**1429 ECK ROAD OUTDOOR STORAGE**  
**MAJOR PLAN 2022-109**  
**ATTACHMENTS**

**TO: PLANNING COMMISSION**  
**FROM: GREGG R. ADAMS, PLANNER**  
**SUBJECT: 1429 ECK ROAD OUTDOOR STORAGE**  
**MAJOR PLAN 2022-109**  
**REQUEST FOR PRELIMINARY/FINAL PLAN REVIEW**

**SUBJECT:** South Whitehall Township  
1429 Eck Road Outdoor Storage  
Major Plan #2022-109  
Preliminary/Final Plan Review

**PRELIMINARY/FINAL RECORD PLAN**

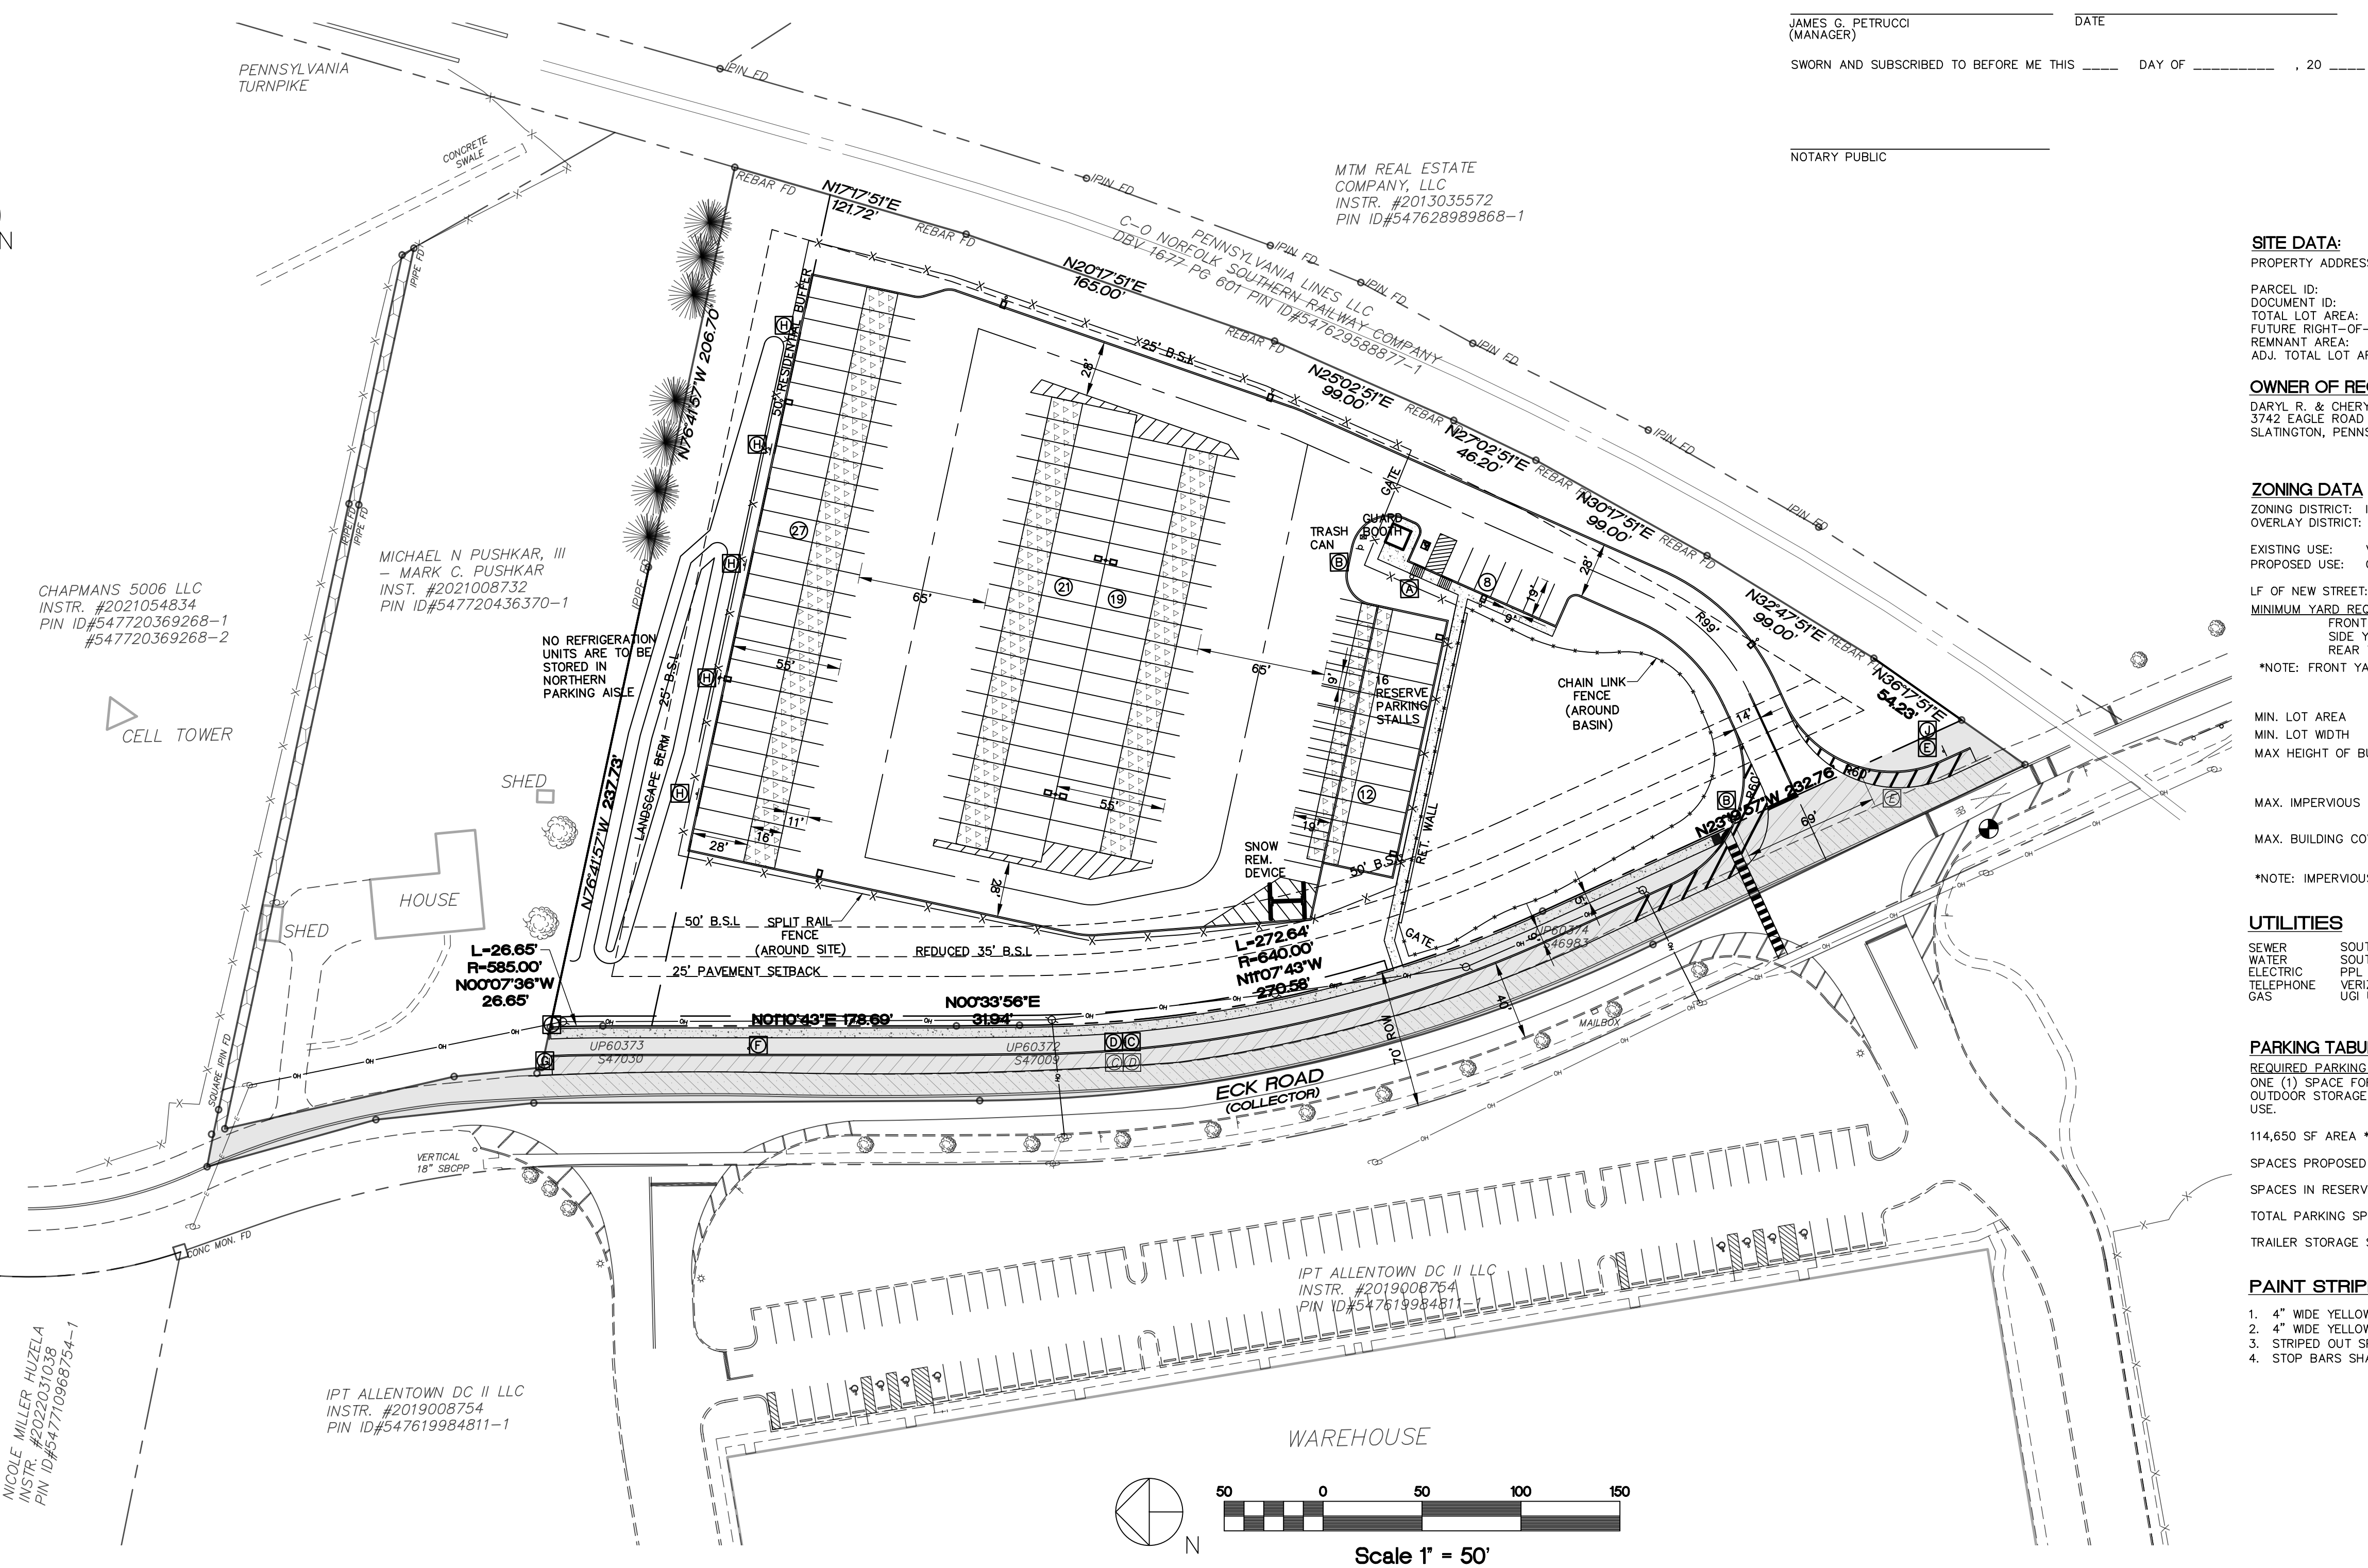
All waivers and deferrals in the waiver request letter should be listed on the Plans.

1. Provide required and available sight distances for the proposed driveway (based on PennDOT Stopping Sight Distance criteria) and label the sight triangles on the Record

Plan. Provide No Parking Signing along Eck Road to the north of the driveway to maintain the clear sight triangles, SALDO §312-35(a)(6)(F) and §312-12(b)(24);

**PRELIMINARY/FINAL LANDSCAPING PLAN**

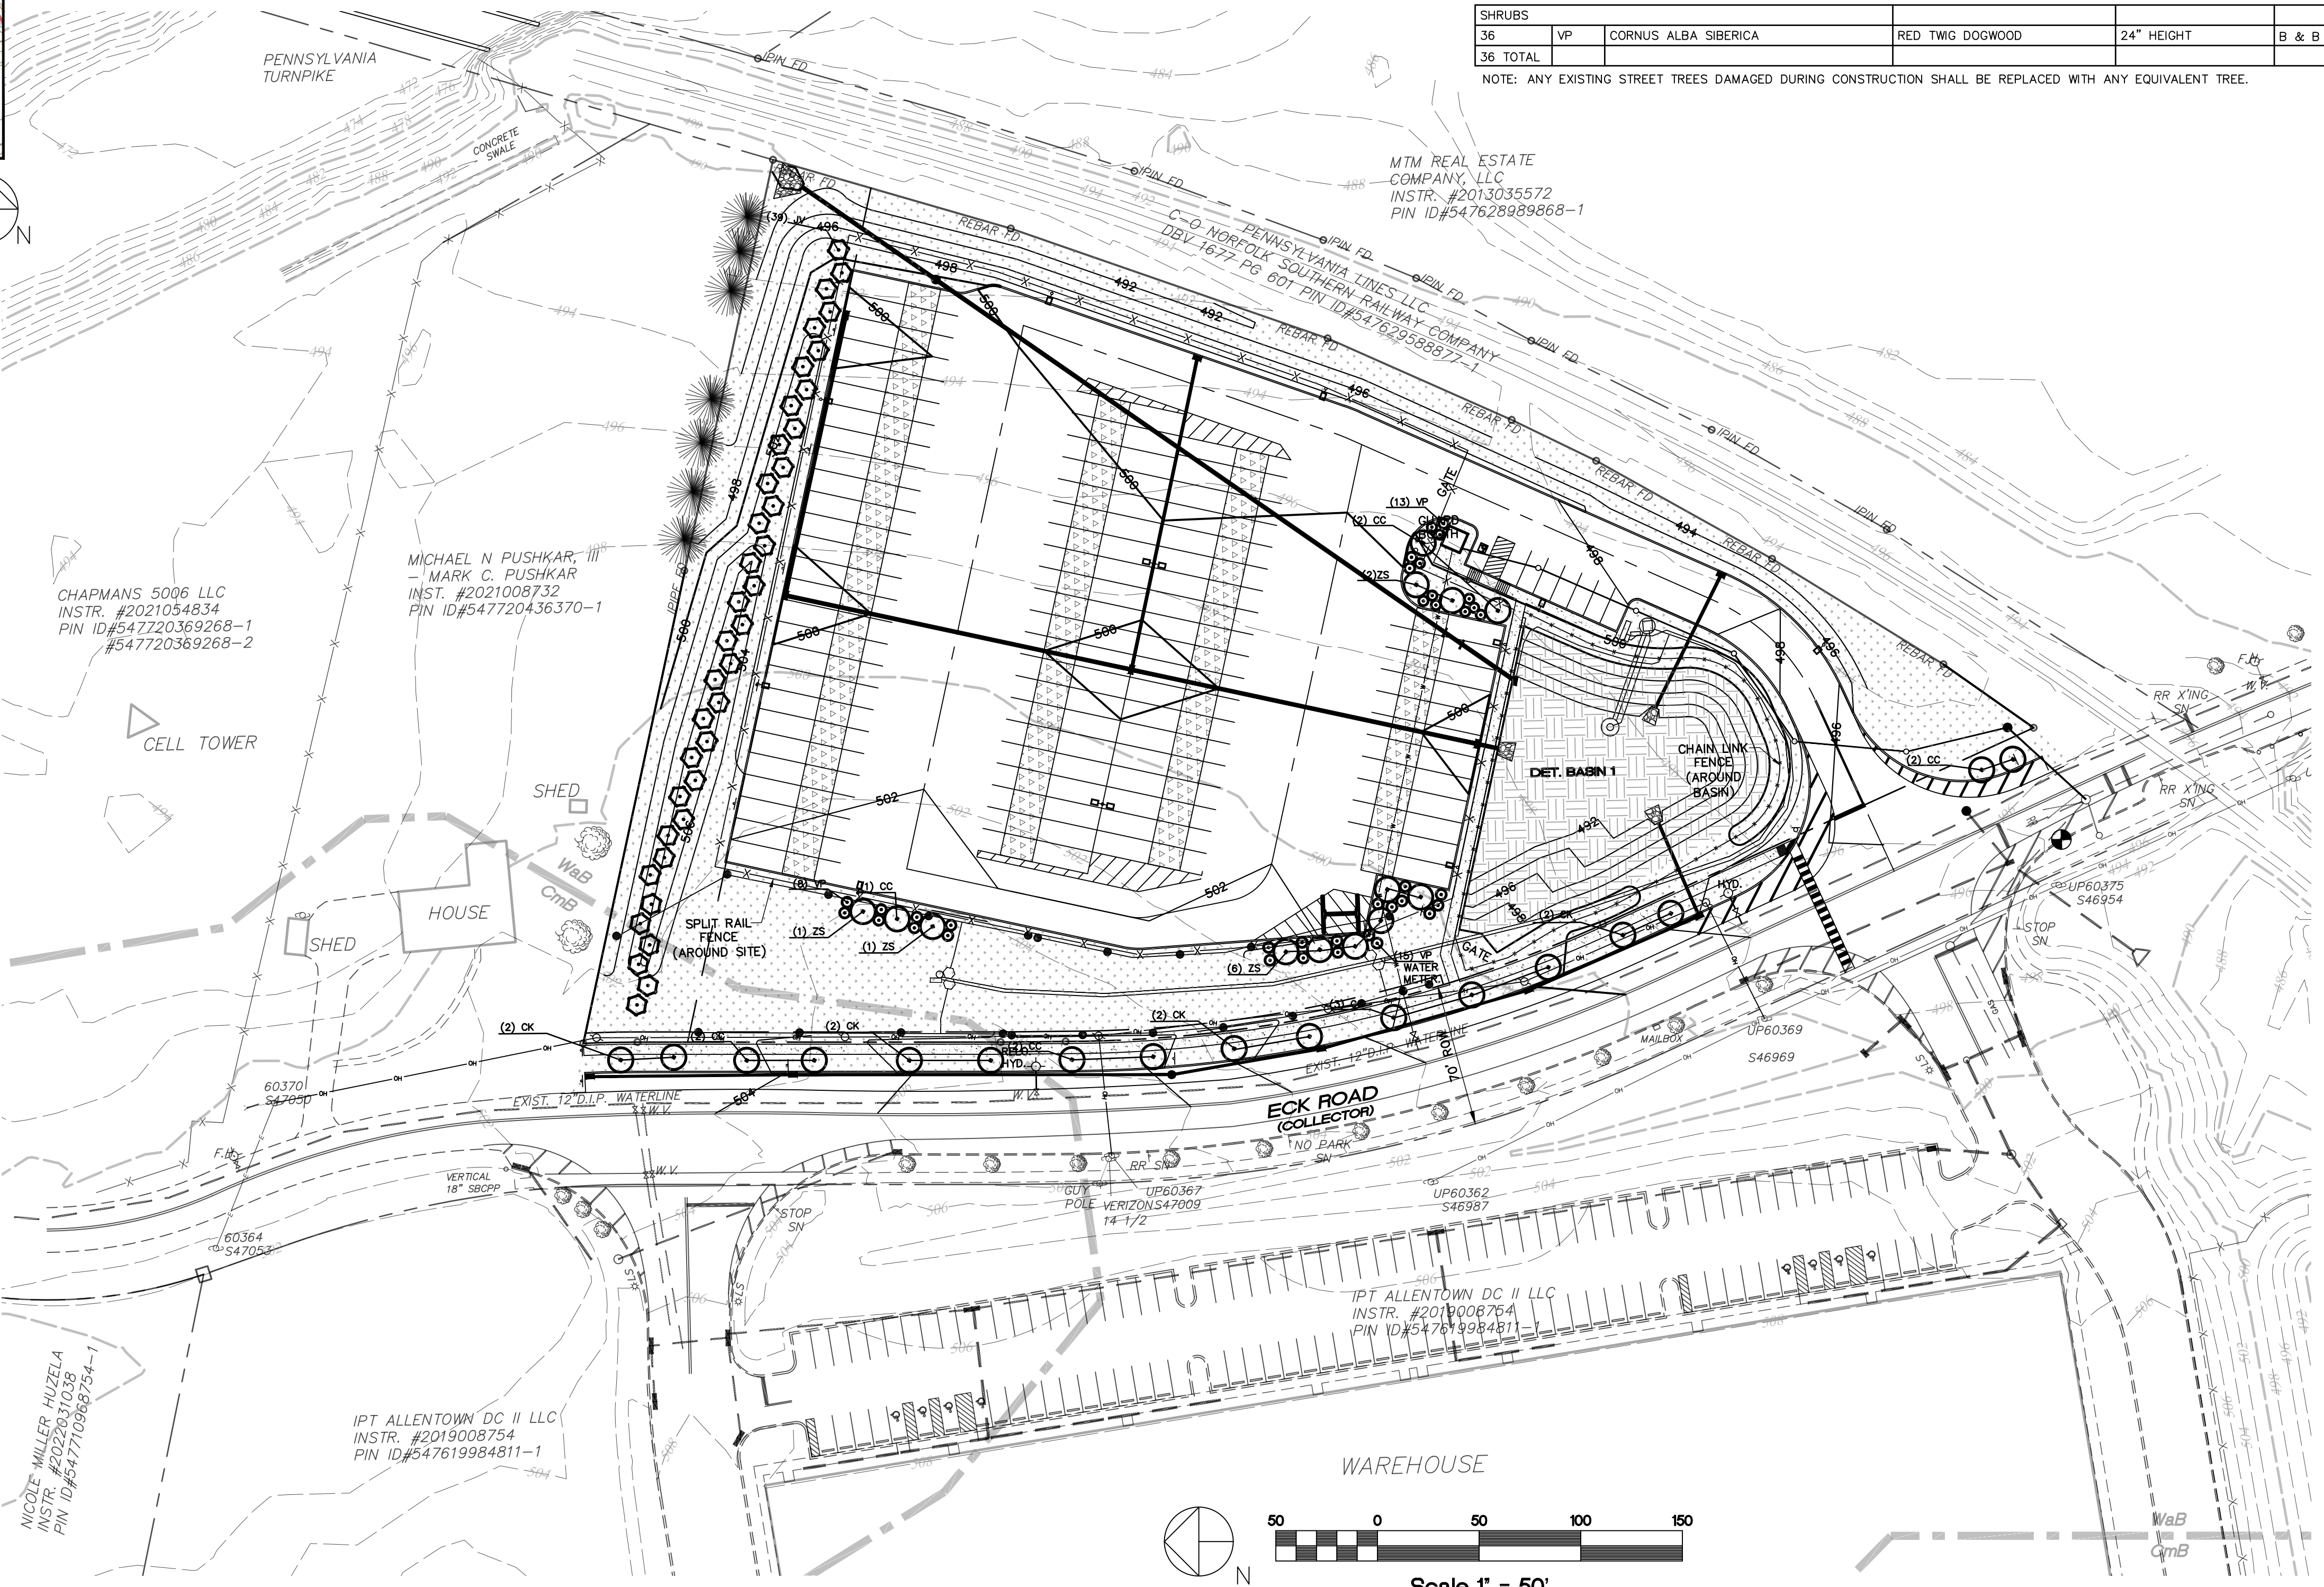
- 1. At their October 23, 2023 meeting, the Landscape and Shade Tree Commission reviewed the above-mentioned plan and recommended the following:
  - a. The Shade Tree Commission recommended that species resistant to Verticillium Wilt be used. The Commission noted that overhead wires are near the proposed tree locations. It recommended that the species be chosen from the In Tight Areas or Under Overhead Wires categories of Preferred Species. The Commission also noted that the two southernmost street trees are proposed outside of the right-of-way of Eck Road. The Commission recommended that the trees either be moved to within the right-of-way of Eck Road or be placed within a Shade Tree Easement.

The Shade Tree Commission recommended that species resistant to Verticillium Wilt be used. The Commission noted that overhead wires are near the proposed tree locations. It recommended that the species be chosen from the *In Tight Areas* or *Under Overhead Wires* categories of *Preferred Species*.
